Division: Civil Engineering
 Your Reference:
 Our Reference: 20060/NH/E01-1
 Date: 17 March 2025

BEAUFORT WEST SOLAR PV ENERGY FACILITY: SPECIALIST LETTER OF OPINION FOR EA PART TWO AMENDMENT – TRAFFIC STUDY

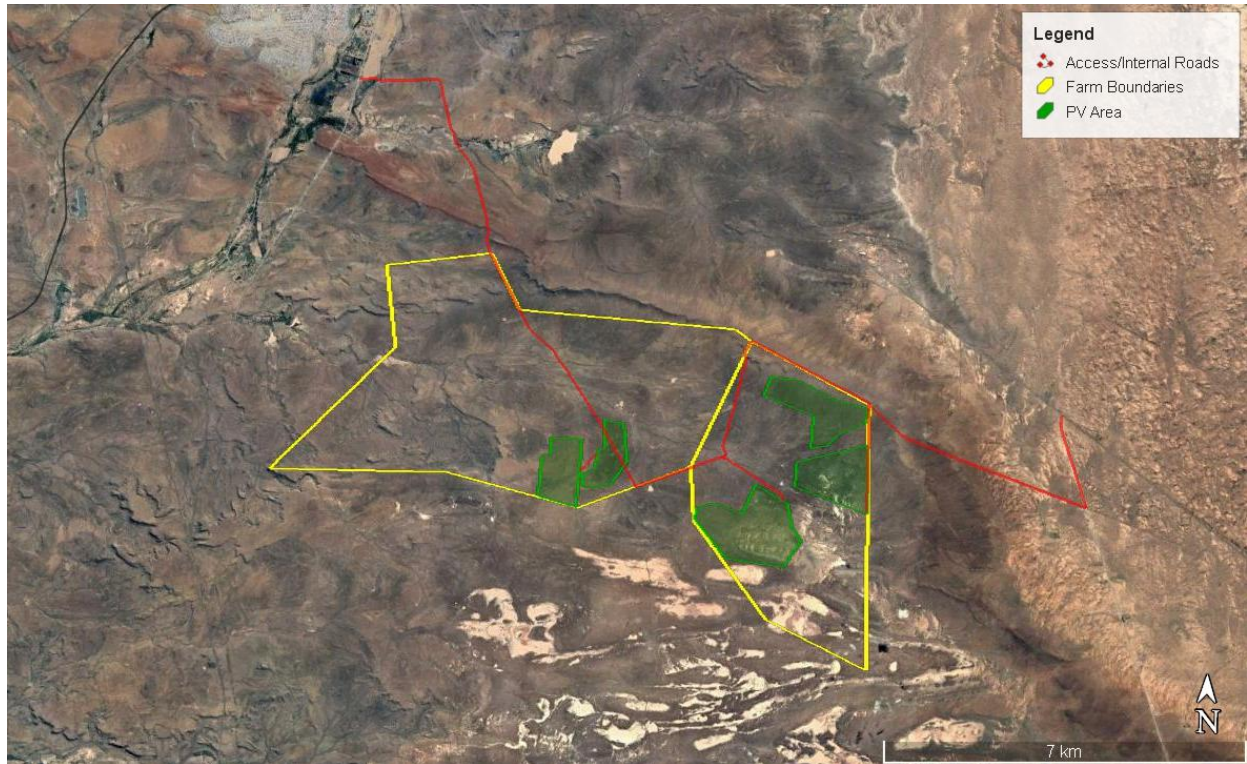
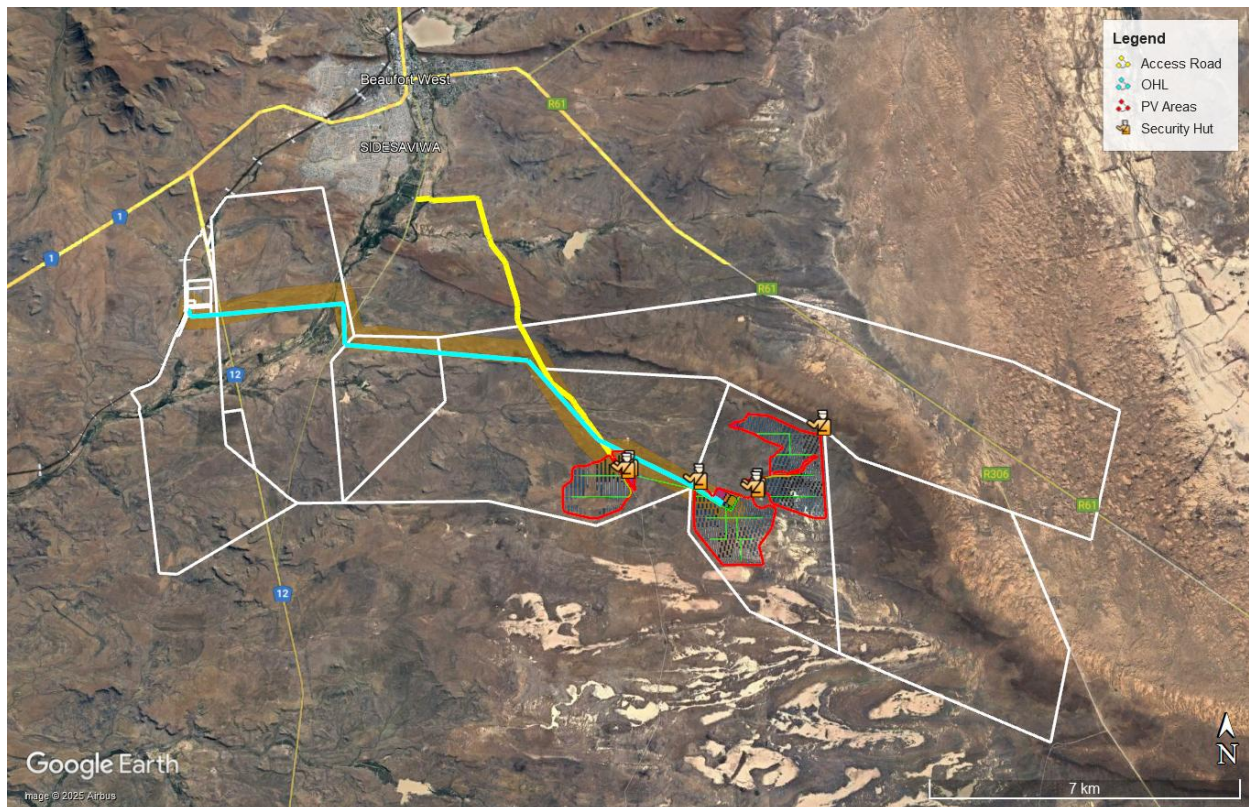
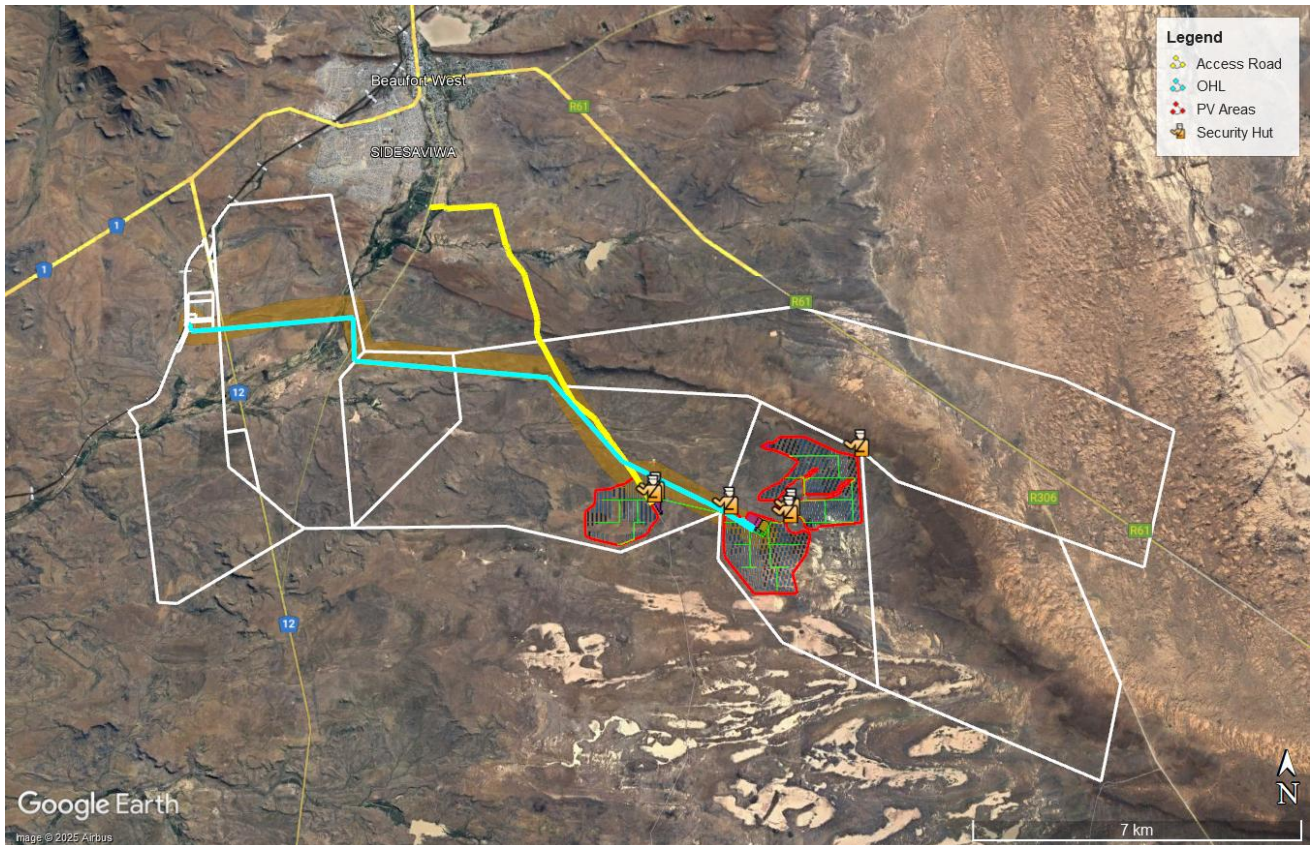
- The configuration of the solar PV areas has been amended to avoid additional sensitivities while retaining the maximum generation capacity of 415 MW. The re-configuration does not alter the scope of work that in any way that would affect the findings of the original traffic study.

- The footprint of the on-site substation changes slightly but remain within the approved area of 2 ha. This change is thus deemed to have a negligible impact on the traffic study.

- Additional laydown areas have been introduced. Original laydown areas were approximately 9 ha whereas the latest layout proposed laydown areas of approximately 16.2 ha. The additional laydown areas will increase the volumes of construction traffic.

- A construction site is included in the updated layout. However, the construction site falls within the footprint of the laydown areas discussed above and therefore does not have an additional impact.

- The access road width is increased from 6 m to 8 m while internal road widths are increased from 5 m to 6 m. The increased road widths will require additional layerworks and hence will result in increased construction traffic.

- On-site diesel storage of less than 30 m³ is proposed. Such storage will require a concrete-surfaced bunded area capable of containing 110% of the stored volume. The requisite bunded area is estimated to be approximately 33 m² (assuming a containment height of 1 m). The materials necessary for the construction of the bunded area will result in a slight increase in construction traffic.

- Numerous guard houses are proposed on the facility whose construction will result in a slight increase in construction traffic.

- The traffic impacts of the proposed the Beaufort West Solar PV Facility remain low. In terms of TMH 16¹, developments that generate less than 50 peak-hour trips are not required to undertake a detailed Traffic Impact Assessment (TIA). The generated peak-hour traffic for the Beaufort West Solar PV Facility is well below this threshold even after considering the proposed layout changes.
- The cumulative traffic impacts of the proposed amended Beaufort West Solar PV Facility and the surrounding developments also remain low. The findings and recommendations of the original traffic impact assessment in this respect remain valid and applicable.
- The traffic impacts for both the preferred layout and alternative layout are identical and are as assessed above. There is no preference between the two layout alternatives in respect of traffic impacts.

The traffic impacts of the proposed Beaufort West Solar PV Facility, considering the proposed amendments to the original approved development, remain nominal. The findings, impact rating, mitigation measures, and recommendations of the original traffic assessment remain valid and applicable.
